AGENDA
CITY COUNCIL STUDY SESSION
MARCH 13, 2023 - 6:00PM
CITY OF FARMINGTON HILLS
CITY HALL – COMMUNITY ROOM
31555 W ELEVEN MILE ROAD
FARMINGTON HILLS, MICHIGAN
Telephone: 248-871-2410 Website: www.fhgov.com

SUBJECT: Revised Planned Unit Development (“PUD”) 3, 2021

Case: PUD 3, 2021
Site: 32680 Northwestern Highway (Parcel ID 22-23-02-126-130)
Applicant: NWH Holdings, LLC/Robert Asmar
Plan Date: revised 12/16/2022
Zoning: B-2 Community Business and B-3 General Business

NOT FOR CONSTRUCTION **C-3.0A**

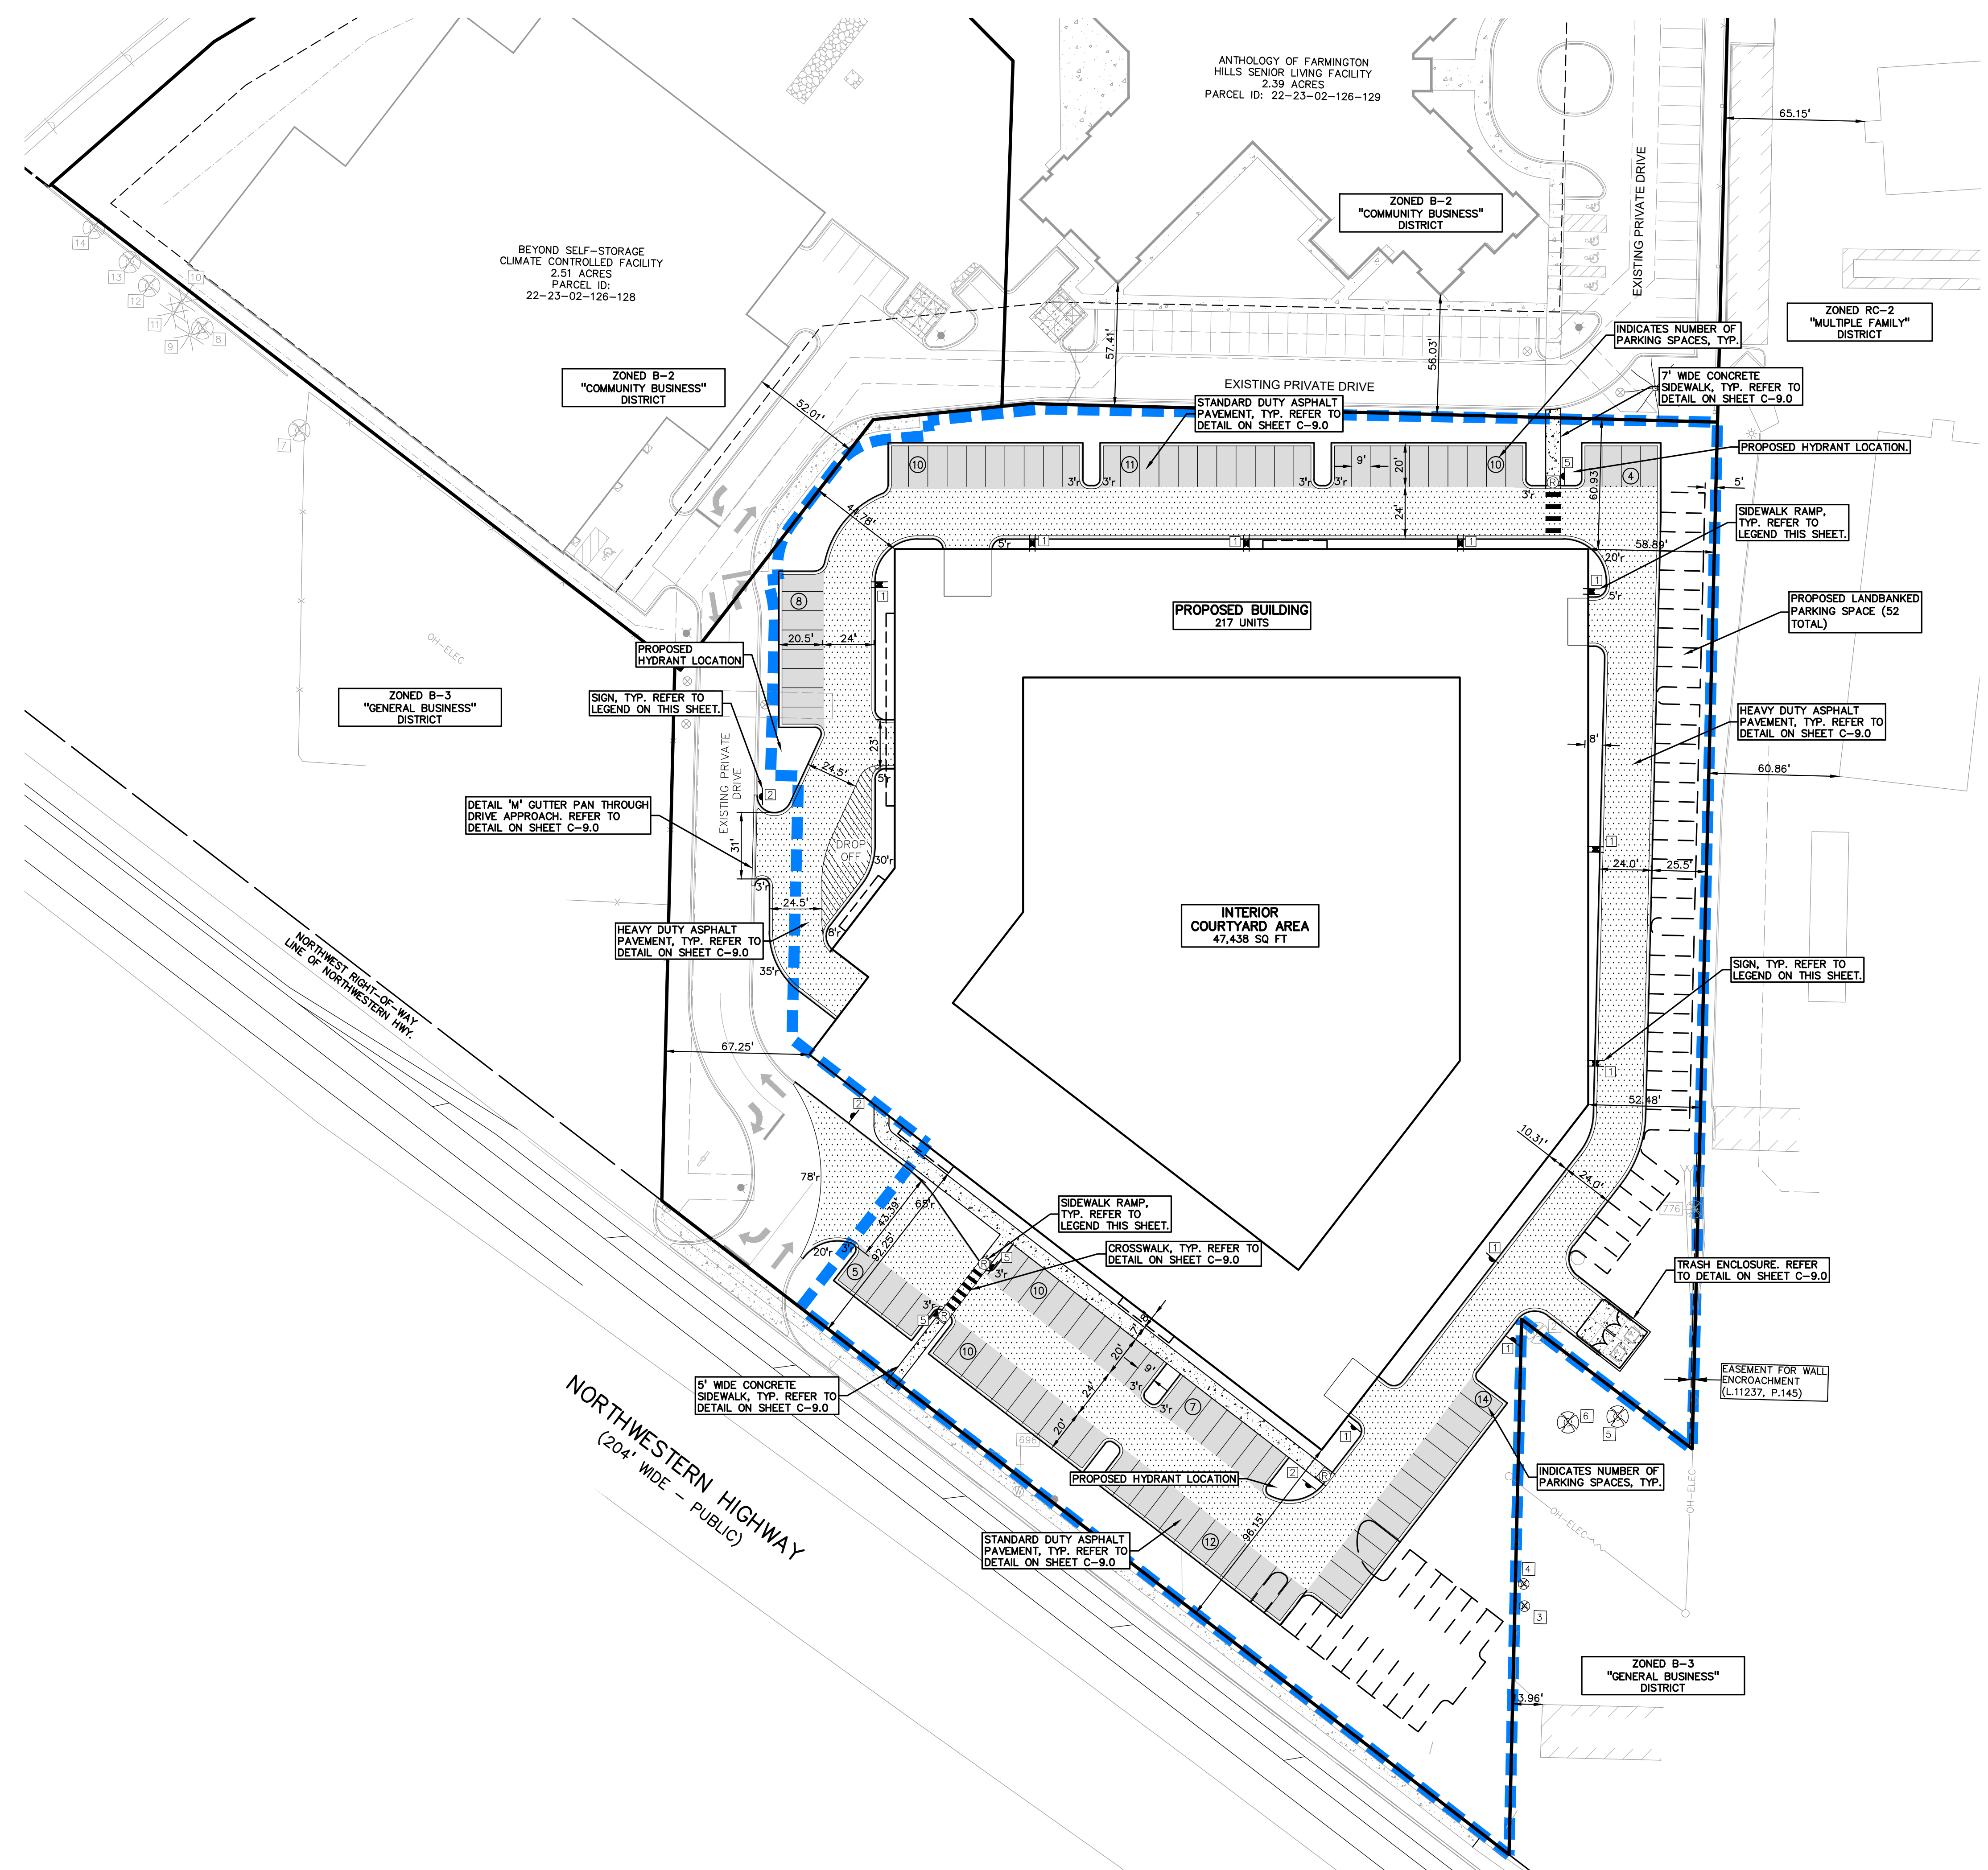
A noteworthy difference between the previous plans and revised plans before you tonight is that the applicant is now showing two (2) alternative surface parking configurations for the site. On Sheet C-3.0, the parking proposed is essentially the same as when the plan was recommended by the Planning Commission, as it provides 365 spaces where 426 are required. On Sheet C-3.0A, by contrast, the parking proposed shows a number of additional land-banked spaces along the east and south sides of the site, which would result in 411 spaces where 426 are required. Therefore, under the alternative shown on Sheet C-3.0A, the applicant would be just 15 spaces short of meeting the parking requirements of the Zoning Ordinance.
